ADDENDUM #1 **Dated: October 28, 2019**

**PROJECT: Lighting System for Baseball Field 2 at Orange Beach Sports Complex
Orange Beach, Alabama
GA#19-212
Bid Date: October 31, 2019 at 10:00AM**

ExE Job 1910-3

CUSTOMER / JOB	DESCRIPTION
MUSCO SPORTS LIGHTING (BASEBALL) ORANGE BEACH, AL.	80(FT) MH CONCRETE POLE (D12 -10006) BASEBALL

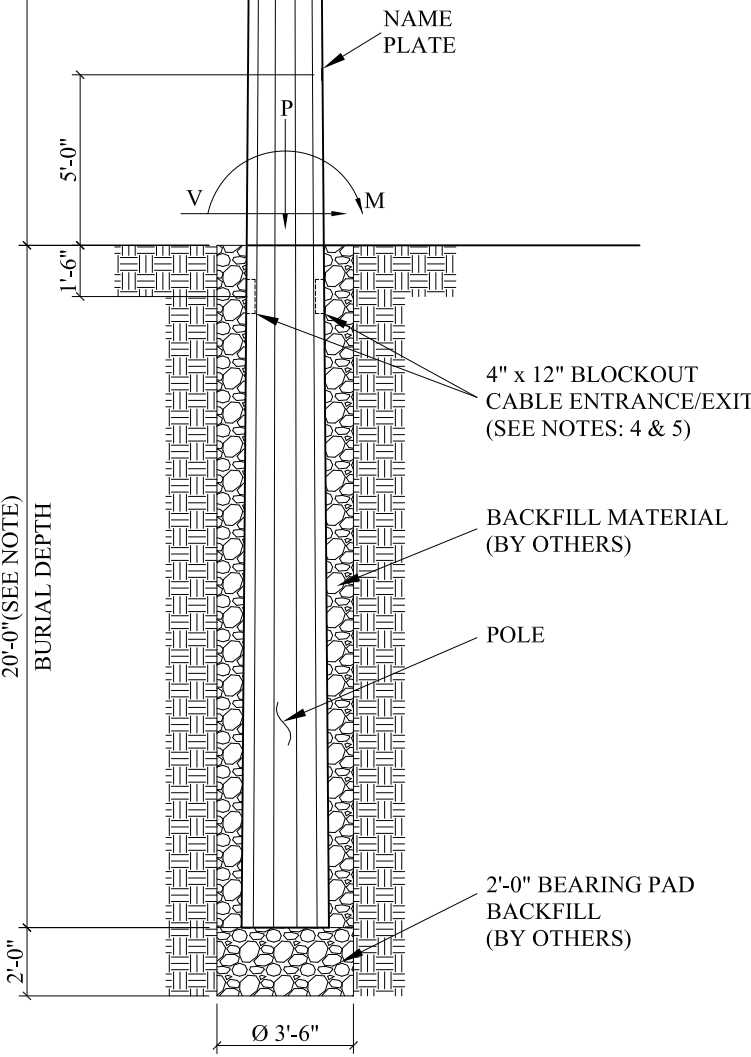
POLE FIXTURE DATA (REF. 196881 CPR SHEET)	
Pole ID:	B1
Fixture Qty.:	9
Total E.P.A.:	25.3(sqft) - assumed to include Bars
lbs at Top:	700 - assumed to include Bars
lbs at ECE:	200

LOADS AT GROUNDLINE	
M(ult.) =	477(ft-k)
S(ult.) =	9.2(k)
P =	20,700(lbs)
(Total weight of Pole)

POLE LENGTH	100'-0"	EPA	25.3 max
LENGTH A.G.H.	80'-0"	CODE	ASCE 7-10
BURIAL DEPTH	*20'-0"	EXPOSURE	C
TIP WIDTH	12.7 in.	RISK CATEGORY	I
BUTT WIDTH	30.7 in.	DESIGN WIND	158(mph)
POLE WEIGHT	20,700 lbs.	POLE SHAPE	Dodecagonal
POLE TAPER	0.18 in./ft.	QUANTITY	1
DRAWN BY	M.D.W.	DATE	9/26/2019

Foundation Calculations, per IBC Method(=FBC Method)

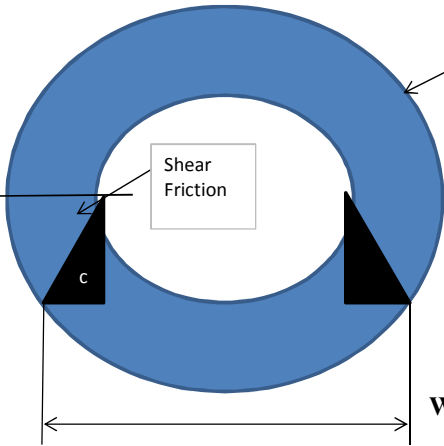
Client: **Baldwin Lighting/ Musco Lighting** Soil Type= **4** (Assumed, see note below)
 Job Name: **Orange Beach Baseball** Proposed Burial Depth= **20.0 ft.**
 Location: **Orange Beach, AL** Diameter of Excavation (De)= **42 in.**
 Pole Width at Groundline(Dp)= **27.1 in.**
 Backfill Material= **4- Crushed Stone**
 Shear Friction angle (a)= **60 degrees**
 Effective bearing width (W)= **36.6 in.**

Applied Moment= **477.000 ft. kips** Load Factor= **1.60** (enter 1 if service loads)
 Applied Shear (P)= **9.200 kips** Equiv.Hgt.(h)= **51.8 ft.(h)**

So $S_i = 1596$ psf $A = 2.76$
 Req'd. depth= **13.95 ft.** $d' = 20.0$
 $d/d' = 1.434$

Burial Depth OK, per IBC Method
